Re: **COMBINED STORMWATER MANAGEMENT  
CONCEPT/SITE DEVELOPMENT  
STORMWATER MANAGEMENT PLAN** for  
7359 Wisconsin Avenue  
Preliminary Plan #: 120180040  
SM File #: 283281  
Tract Size/Zone: 0.84 Ac.  
Total Concept Area: 1.09  
Lots/Block: 6-11 / 4  
Watershed: Lower Rock Creek

RE: 7359 Wisconsin Avenue  
Traffic Impact Study  
Montgomery Avenue Analysis

RE: Sketch Plan No. 320180040  
Preliminary Plan No. 120180070  
7359 Wisconsin Avenue

**DATE:** 16-Jan-18  
**TO:** Michael Goodman  
VKA, Inc  
**FROM:** Marie LaBaw  
**RE:** 7359 Wisconsin Ave  
820180040

**Fire Department Access Review**

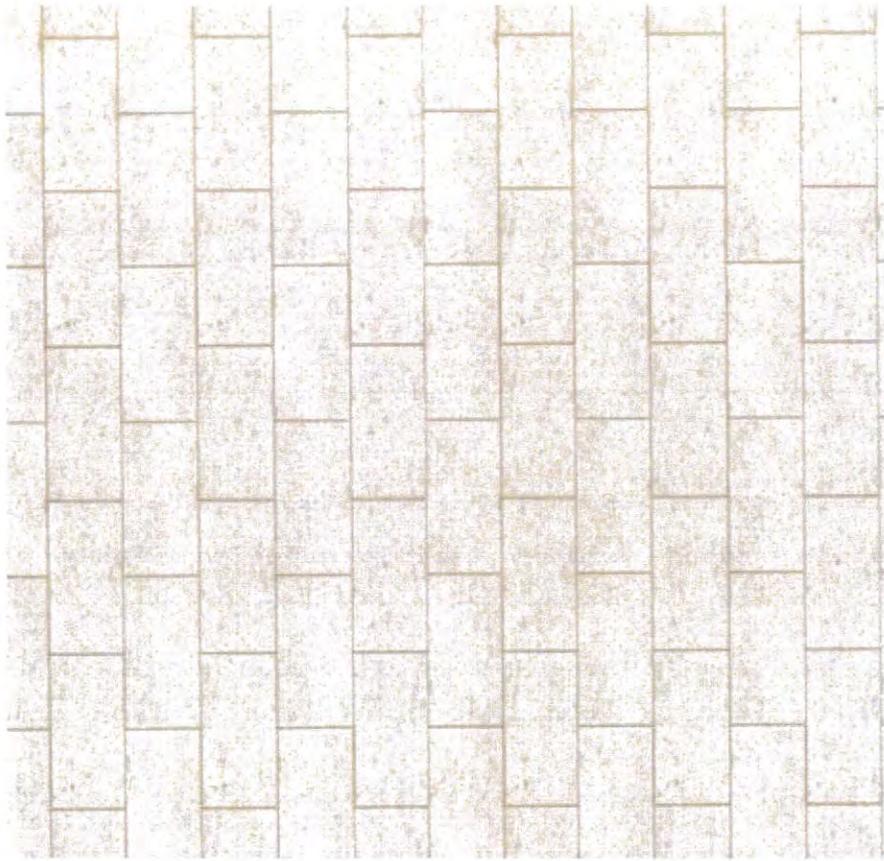
In order to meet the prescriptive code requirements for this project we have provided an access lane onto the site from Wisconsin Avenue. The fire access lane will be delineated with a special paver that will extend to all areas of the building below that meet the structural requirements for the 85,000 lb loading. This area will be accessible to fire trucks via a mountable curb (MC-104.1) and will extend to the building overhang to the east and to a building column to the north which will act as a physical and/or visible barrier to non-load bearing areas of the structure.

Review based only upon information contained on this plan. Does not cover unsatisfactory layout resulting from omissions, errors or failure to clearly indicate conditions on this plan. Correction of such unsatisfactory layout to afford required access will be required if found upon inspection after installation
